Freightliner  
Service Bulletin

## General Information

Cummins ISX engines in EPA10 Cascadia and Coronado models have one of two heat shields installed to protect the air intake ducting from possible high temperatures. Further testing has determined that this heat shield is not needed. If damaged, the heat shield should be fully removed, and not replaced. If the heat shield is not damaged, no action is necessary.

Fig. 1, Heat Shield Removal, No-Bracket Design

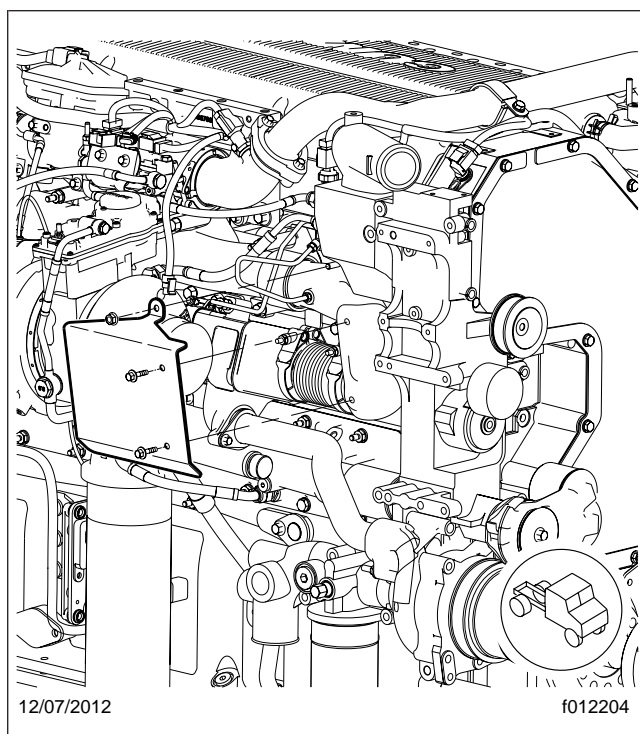
Both heat shield designs have three mounting points. See [Fig. 1](#) and [Fig. 2](#). The heat shield installation that includes a lower bracket should also have the bracket removed, so it cannot vibrate and cause stress at the mounting points. Access to the lower-rearward nut on this bracket may be difficult due to the EGR pipe. To loosen the nut, use a 13 mm 1/4-inch-drive U-joint swivel socket; see [Fig. 3](#). Depending on the brand of socket, it may be necessary to trim the length of the socket slightly to gain enough clearance to remove the nut.
